**From:** [REDACTED]  
**Sent:** Sunday, 18 April 2021 1:46 PM  
**To:** Council Mailbox <[council@northernbeaches.nsw.gov.au](mailto:council@northernbeaches.nsw.gov.au)>  
**Subject:** DA2021/0311 - Boarding House at 2 The Circle Narrabeena

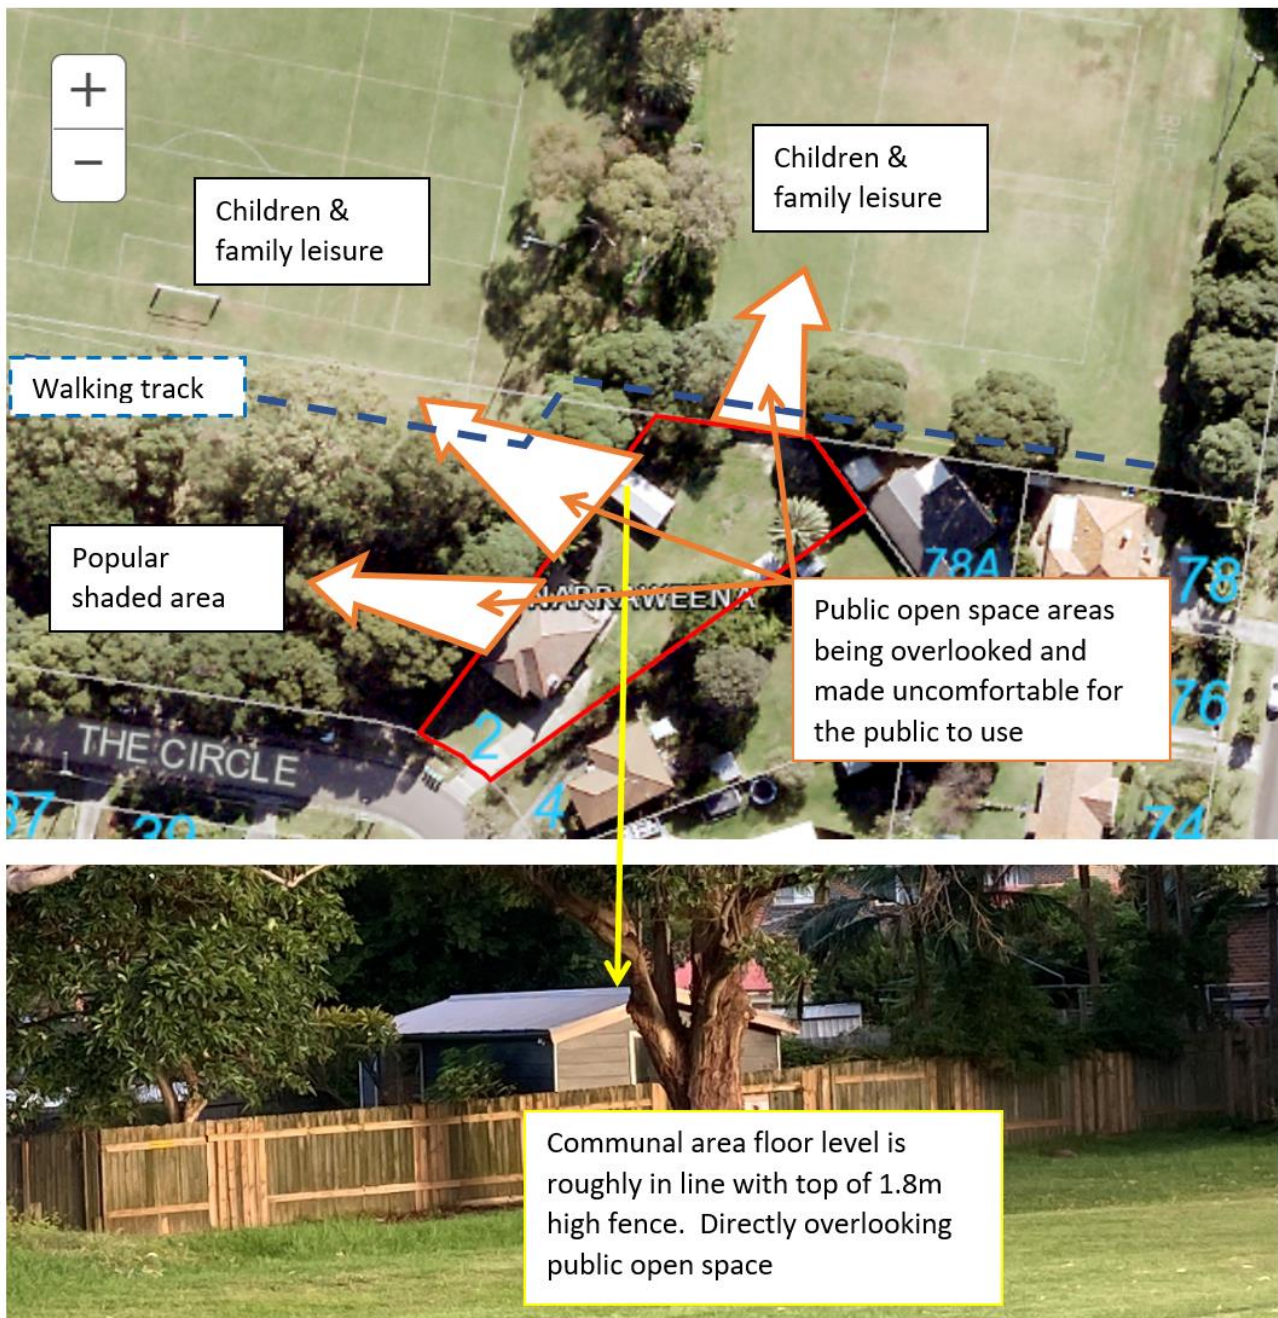
I would like to know how many garbage bins would ever be placed on the nature strip at any one time. Because there is very narrow street frontage where these can be positioned, such that this will limit the maximum allowable number of bins for this lot. It will also be difficult for a large waste removal truck to safely clear a high number of bins on this corner and place them back down so they do not block the path for the public (including wheelchairs), and also to prevent the bins falling onto the road around this tight bend (potentially causing an accident).
